REQUEST #1 TREE #5 - 7X AWAY FROM A PROPOSED POOL HOUSE

| NEW HOUSE FOR<br>TMM INVESTMENTS, LIMITED<br>29 STOCKBRIDGE AVE.<br>ATHERTON, CA |

| TPZ                 |

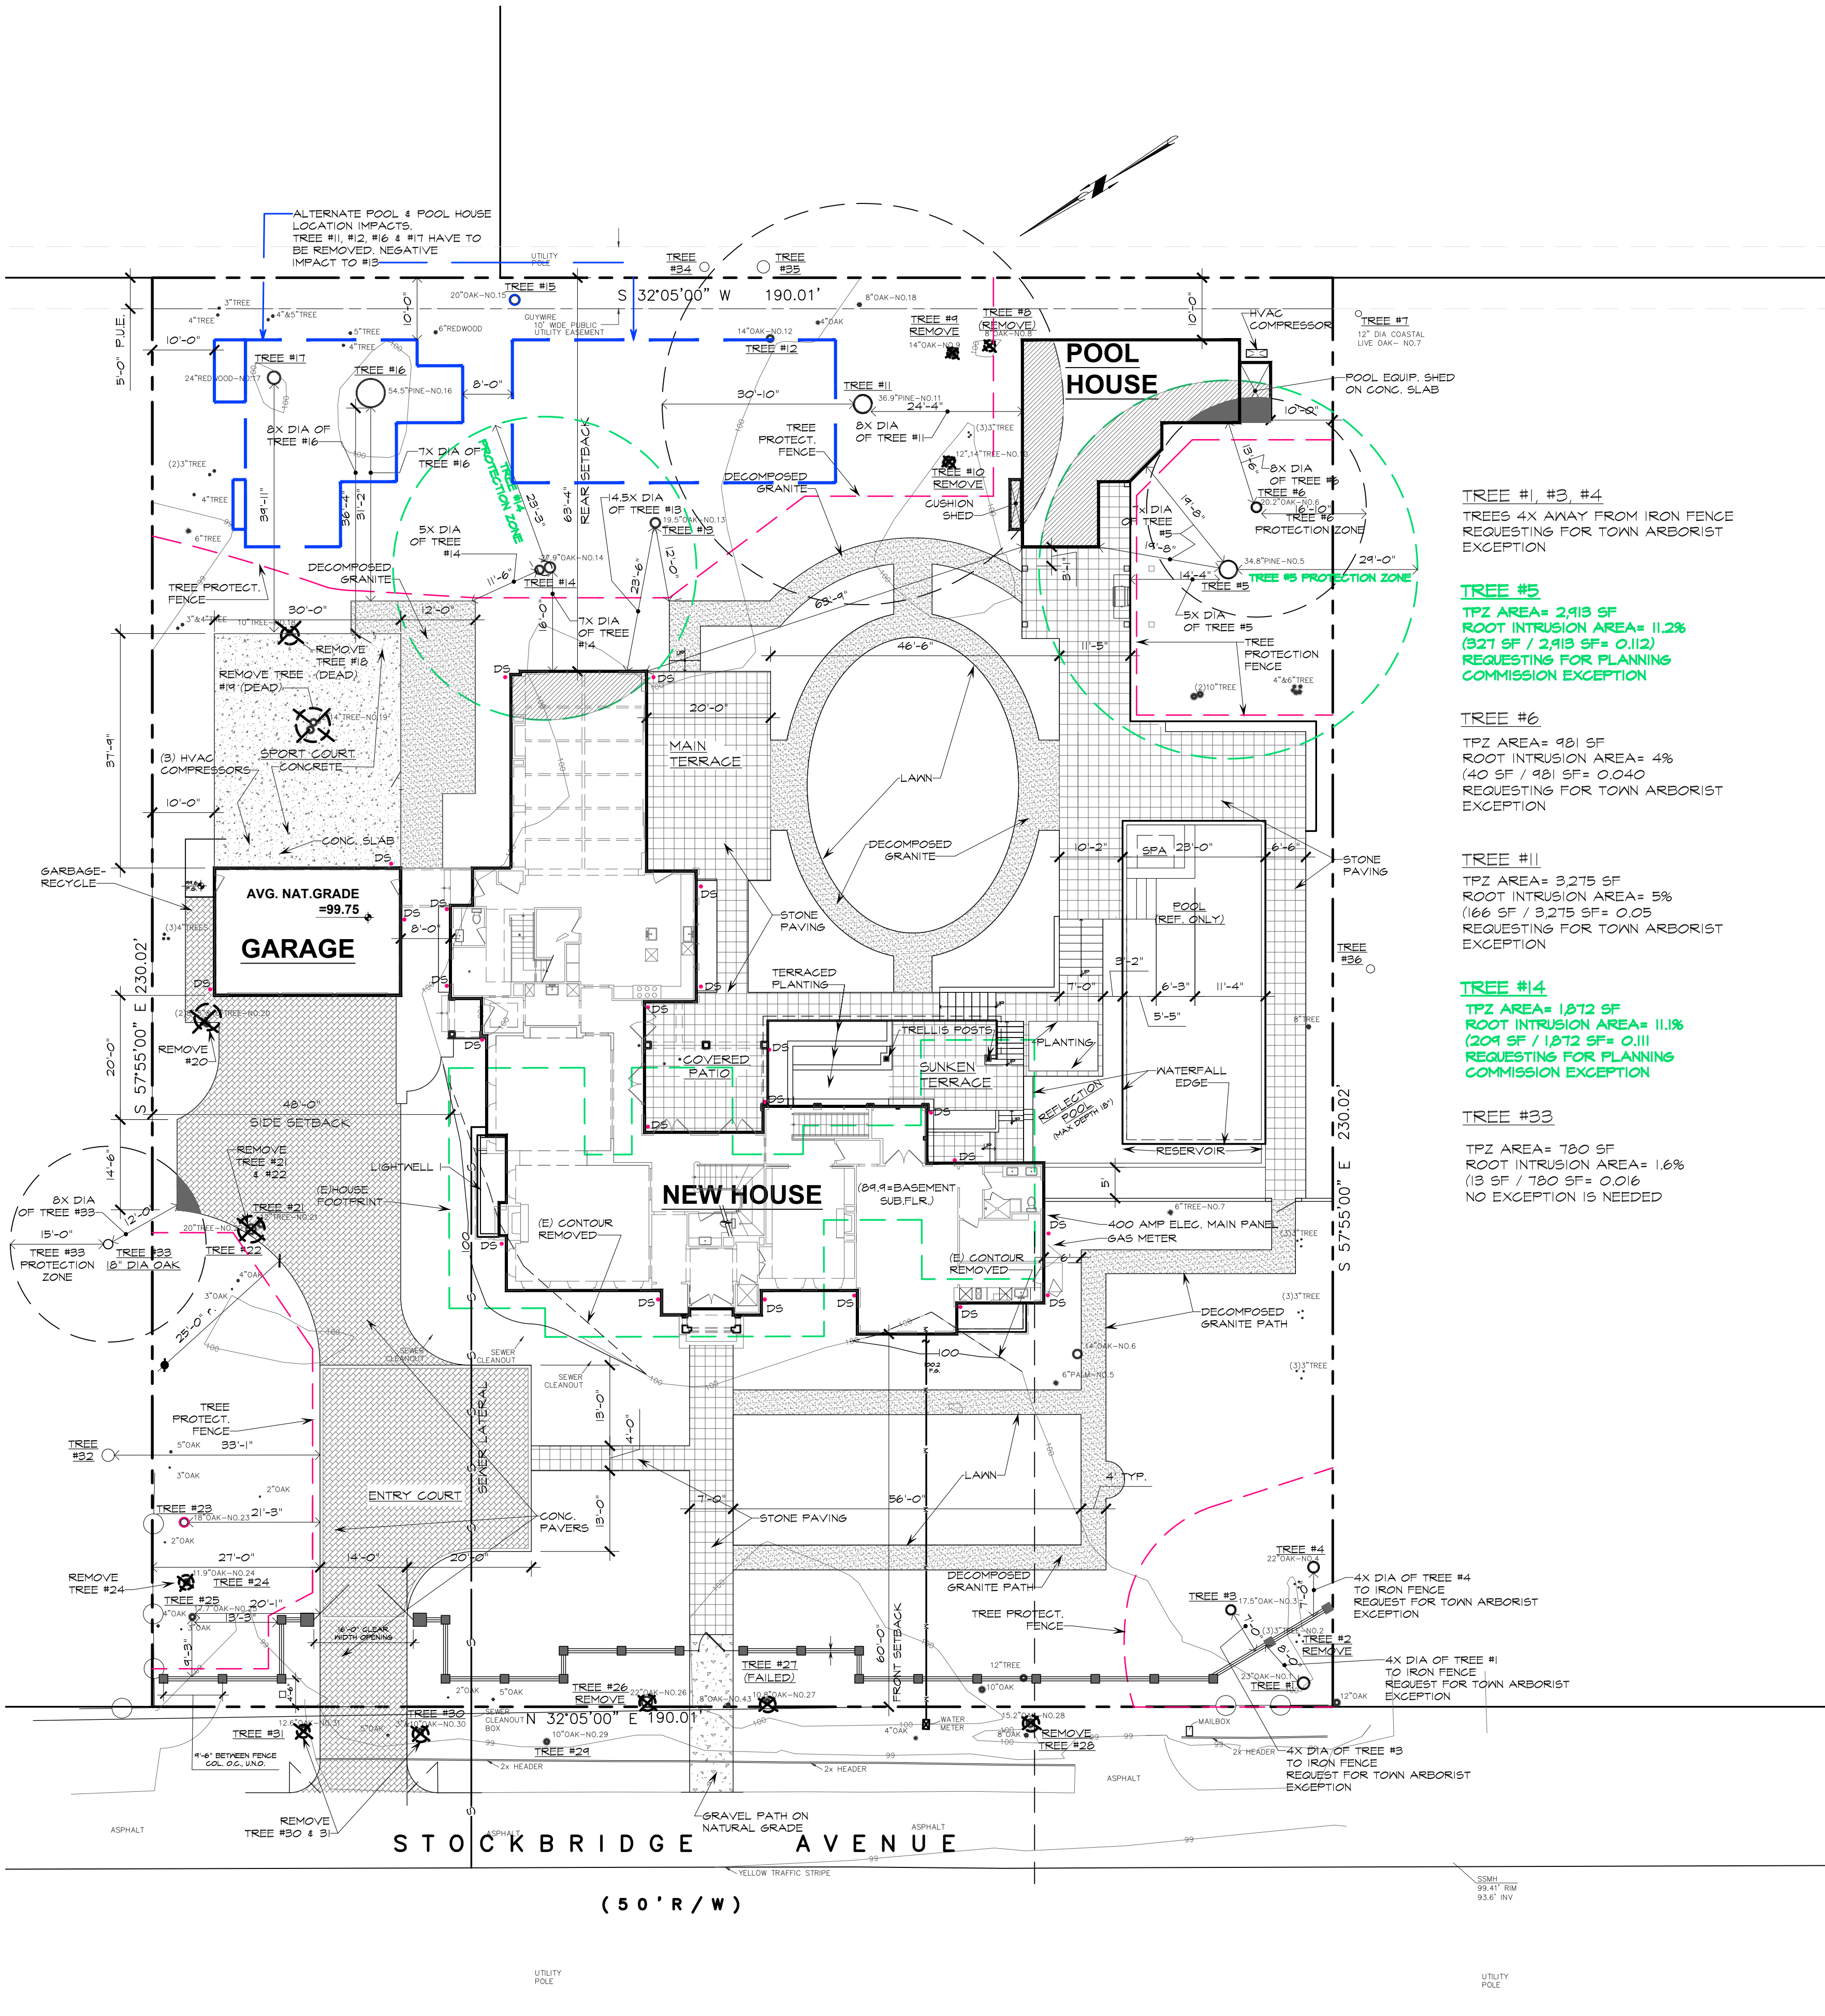
REQUEST #2- TREE #14 - 7X AWAY FOR A PROPOSED MAIN HOUSE

Due to the fact that no roots 2" and less were found, The town arborist can recommend 7x away or 16' away. Town Arborist recommends 7x with the below private arborist recommendation. All excavation is to be done by hand under the Project Arborist supervision when within 10x the tree's diameter. Any roots encountered are recommended to be retained within the decomposed granite area by packing rock or granite around tree roots. Between the home and tree and decomposed granite area, it is recommended to irrigate the soil when within 10x the tree's diameter using 200 gallons of water before the start of excavation for the foundation and again 2 weeks later. This will act as mitigation for the minor impacts.

Hand excavation under the Project Arborist supervision is required for excavating the foundation of the pool house when working within 10x the tree's diameter. All roots encountered measuring 1" in diameter or larger will need to be documented in the required monthly inspections. Encountered roots are recommended to be cleanly cut with cut root ends on the tree side covered in layers of wetted down burlap. This will help to avoid desiccation. Between the pool house and tree, it is recommended to irrigate the soil when within 10x the tree's diameter using 200 gallons of water before the start of excavation for the pool house foundation and again 2 weeks later. This will act as mitigation for the minor impacts. Irrigation will be prescribed during the monthly inspections as needed.

- All excavation is to be done by hand under the Project Arborist supervision when within 10x the tree's diameter.
- Irrigate the soil when within 10x the tree's diameter using 200 gallons of water before the start of excavation for the foundation and again 2 weeks later.
- All roots encountered measuring 1" in diameter or larger will need to be documented in the required monthly inspections. Encountered roots are recommended to be cleanly cut with cut root ends on the tree side covered in layers of wetted down burlap.
- Mulch should cover all bare soil within the tree protection fencing. This material must be 6-8 inches in depth after spreading, which must be done by hand. Coarse wood chips are preferred because they are organic and degrade naturally over time.
- Sufficient tree protection installed.
